Mobile Intel[®] Pentium[®] II Processor Specification Update

Release Date: August 2001

Order Number: 243887-033

The Mobile Pentium[®] II processor may contain design defects or errors known as errata which may cause the product to deviate from published specifications. Current characterized errata are documented in this Specification Update.

Old Mobile Pentium® II Processor in Mini-Cartridge Package Label with Supplier Matrix Mark

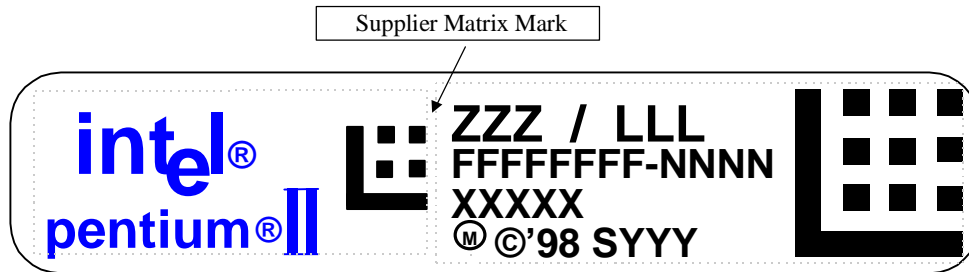
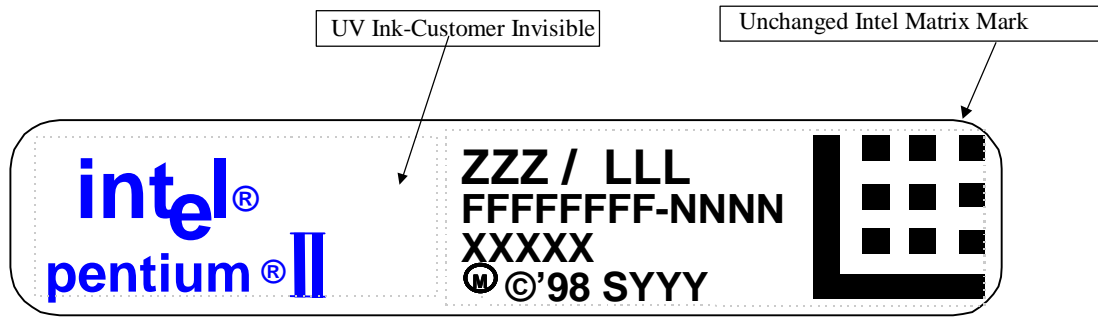
New Mobile Pentium® II Processor in Mini-Cartridge Package Label with Supplier Matrix Mark Removed

Figure 2. Workaround Flowchart: SMBALERT#-Driven System

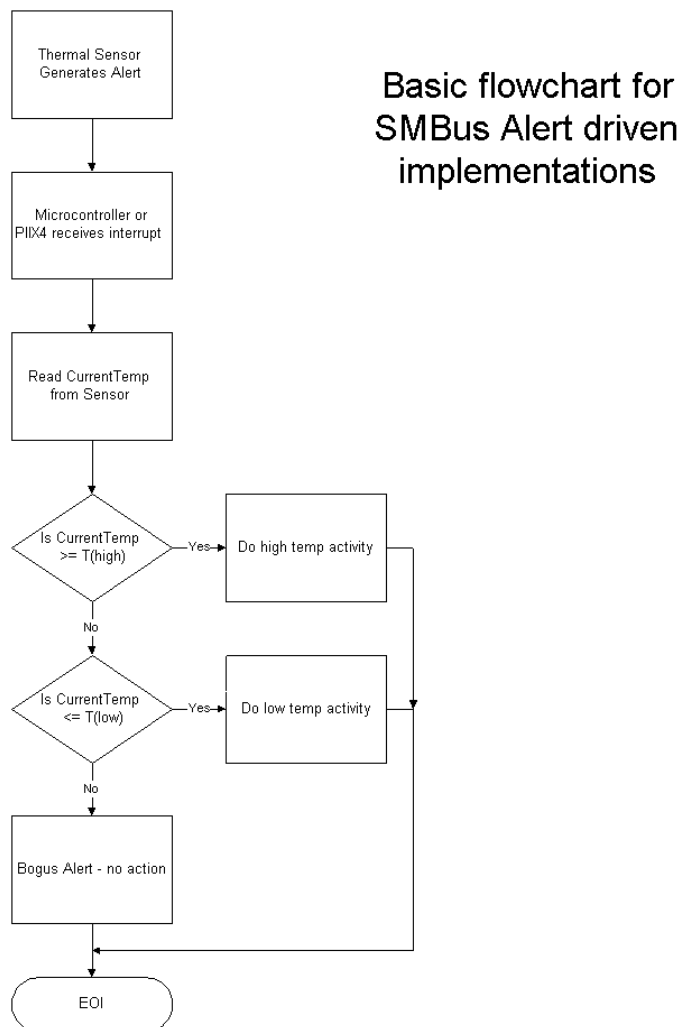
B30. Thermal Sensor May Assert SMBALERT# Incorrectly

1. Before servicing an interrupt from the thermal sensor, read and compare the processor thermal reading with the threshold limits (T_{HIGH} or T_{LOW}). Figures 2 and 3 provide basic flowcharts for the implementation of this workaround in an interrupt driven system.
2. If the firmware implemented polls the Status Register only, then before taking any action, re-read the temperature register and do a comparison with the alarm threshold limits (T_{HIGH} or T_{LOW}) to determine if the value is actually still within the temperature window.

3. Use a temperature polling scheme to monitor the processor temperature.

Figure 5.6. Cross Sectional View with Vertical Dimensions

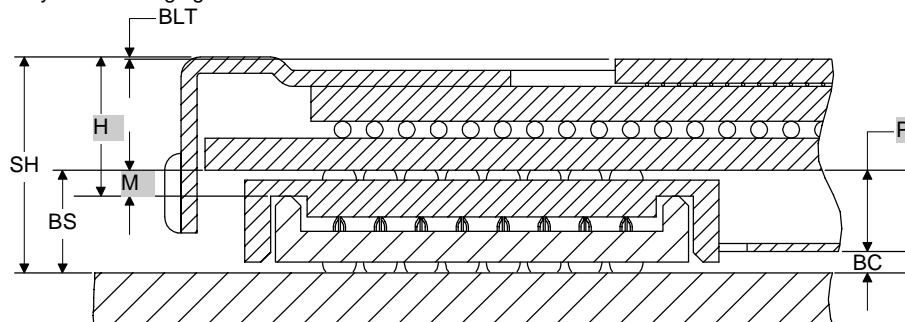
B1. Misabeled Vertical Dimension Parameters

Figure 5.6 in the *Mobile Pentium® II Processor at 233 MHz, 266 MHz, and 300 MHz* datasheet should be replaced by the following figure:

Figure 5.3. Surface-Mount BGA1 Package—Top and Side View

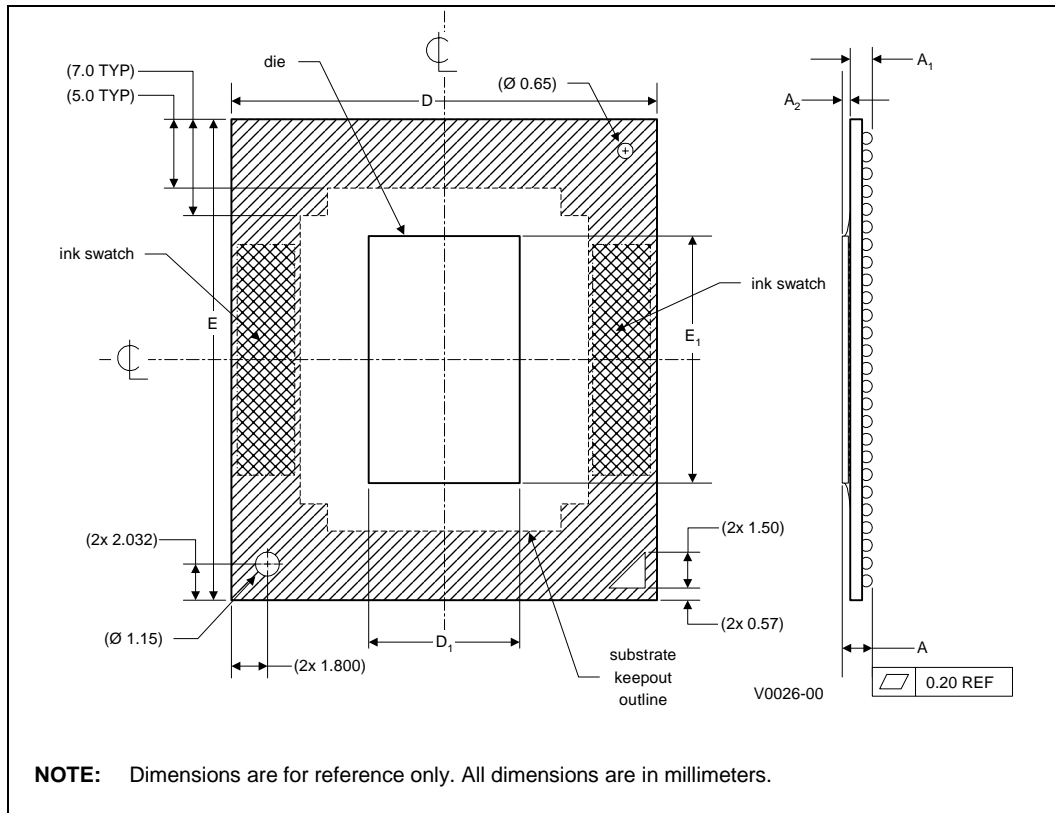
The following table and figures show the updated mechanical specifications for the BGA1 package, listed as Table 5.2, Figure 5.3 and Figure 5.4, respectively, in the *Mobile Pentium® II Processor in BGA Package at 366 MHz, 333 MHz, 300PE MHz, and 266PE MHz* datasheet.

Figure 3.3 Generic Clock Waveform

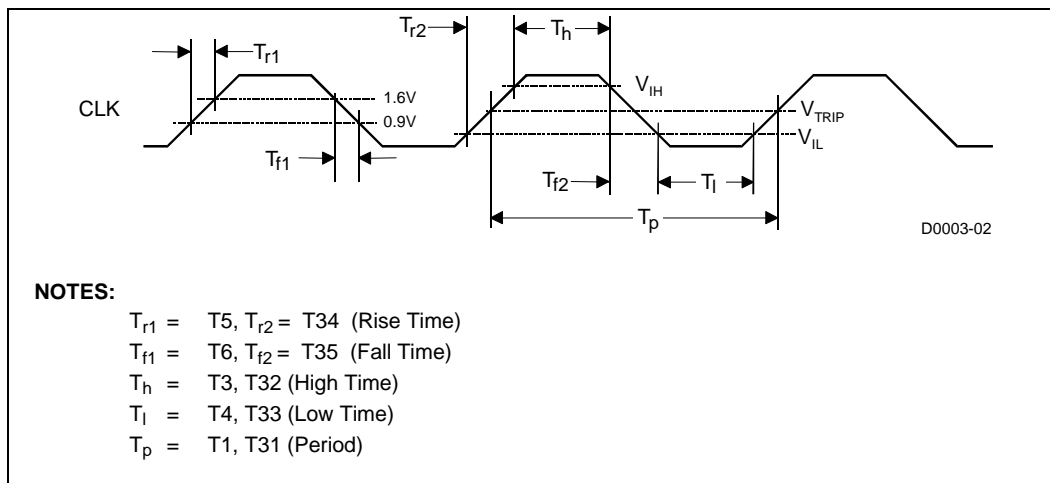
B14. Generic Clock Waveform Figure

Figure 3.3 in *Mobile Pentium® II Processor in Mini-Cartridge Package at 366 MHz, 333 MHz, 300PE MHz, and 266PE MHz* datasheet (Order Number 245108), and the *Mobile Pentium® II Processor in BGA Package at 366 MHz, 333 MHz, 300PE MHz, and 266PE MHz* datasheet (Order Number 245106) has been updated. The following figure is to replace the ones in the above documents.

Figure 1. TAP Gageable Thread Clarification

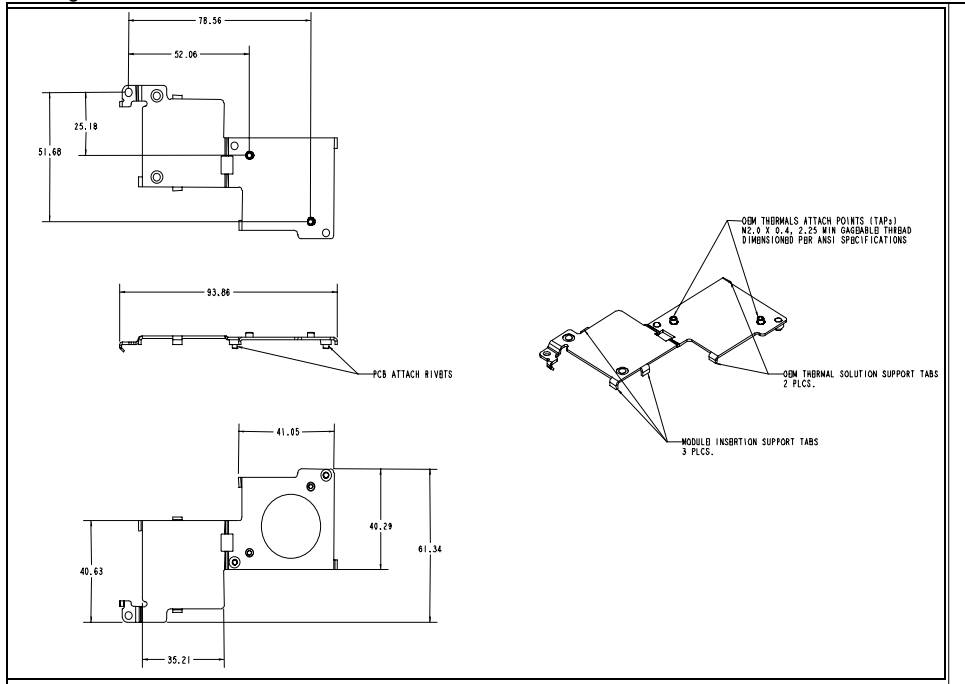
In the *Intel® Pentium® II Processor Mobile Module : Mobile Module Connector 1 (MMC-1)* and the *Intel® Pentium® II Processor Mobile Module : Mobile Module Connector 2 (MMC-2)* datasheets (Order Numbers 243667 and 243668, respectively), the thermal attach point (TAP) gageable thread specification was not clearly identified in Figure 14, of Section 5.2. The following is the TAP clarification:

OEM Thermal Attach Points (TAPs) M2.0 x 0.4, 2.25 min gageable thread dimensioned per ANSI specification.

See Figure 1 below for more information.
